HYDROLOGY K22/D22 4 PLANS

GRADING PLAN
OF
CORTE DE PAZ

REVISED GRADING PLAN

CORTE DE PAZ

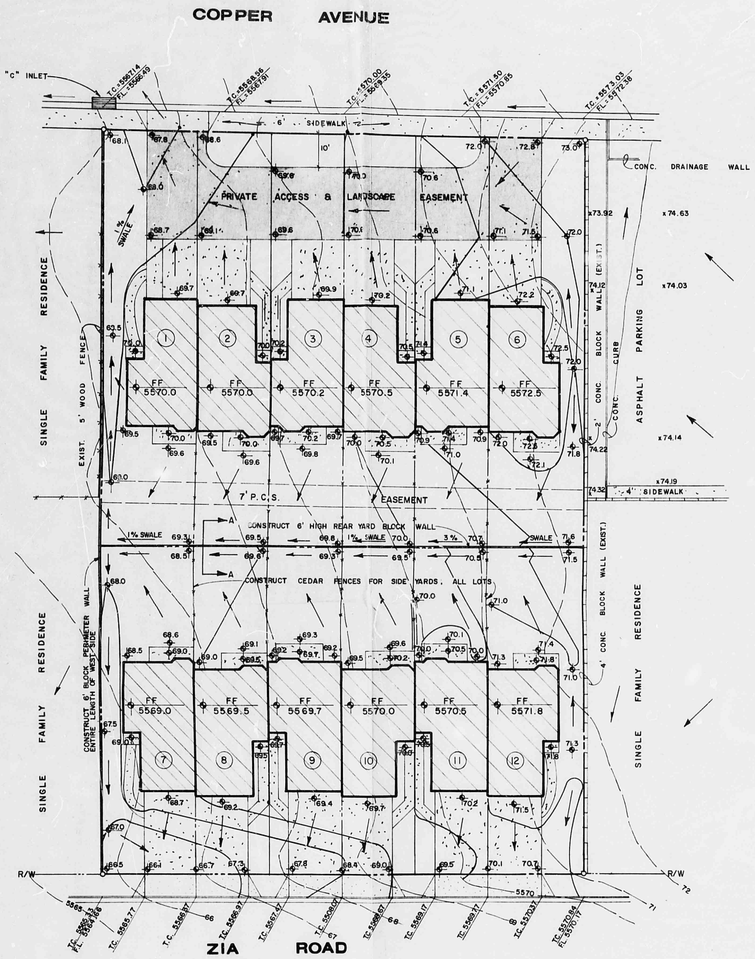
NOTE: Original drainage plan, as outlined by approved drainage report prepared by Bohannan-Huston, Inc., December 1982, called for rear yard ponding of all flows directly generated by rear yard area only. All other flows from roof and front yard areas were discharged to adjacent Copper Avenue and Zia Road.

In subsequent conversations with City Hydrology, Fred Aquirre, the following variations to approved drainage were allowed:

-- Discharge rear yards to adjacent streets via rear yard drainage swales and side yard drainage swales along west property line of lots 1 and 7.

-- Provide private drainage easements for proposed swales.

This variation was allowed due to the undesirability of rear yard ponds and that no credit was given by the City for the rear yard basin discharge in the original report.

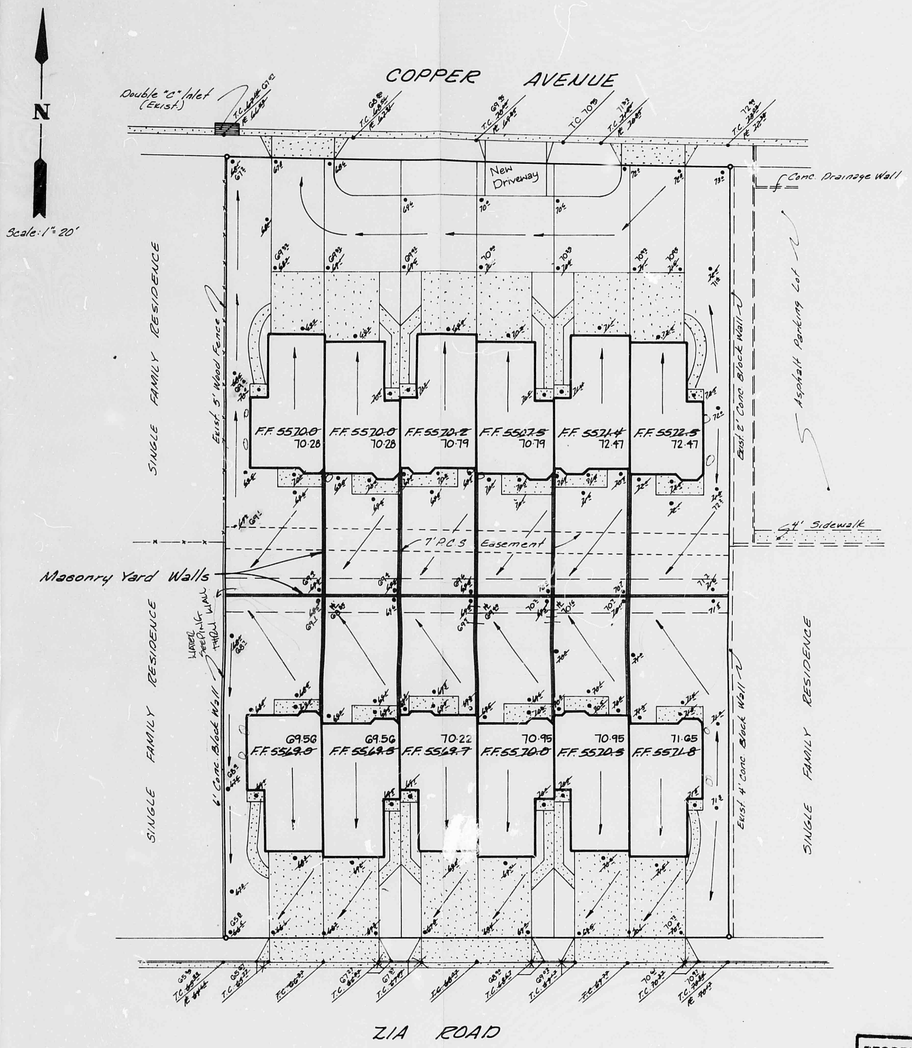
FIELD INSPECTION
4-18-86
① WATER CROSSES WEST PROPERTY LINE THRU WALL INTO ADJACENT PROPERTY
② ROOF DRAINAGE NOT AS SHOWN ON PLAN. DOWN SPOUTS ON SIDE & REAR OF BLDGS.
③ TURNED BLOCKS ONLY AT 12 (TWO) WALLS.
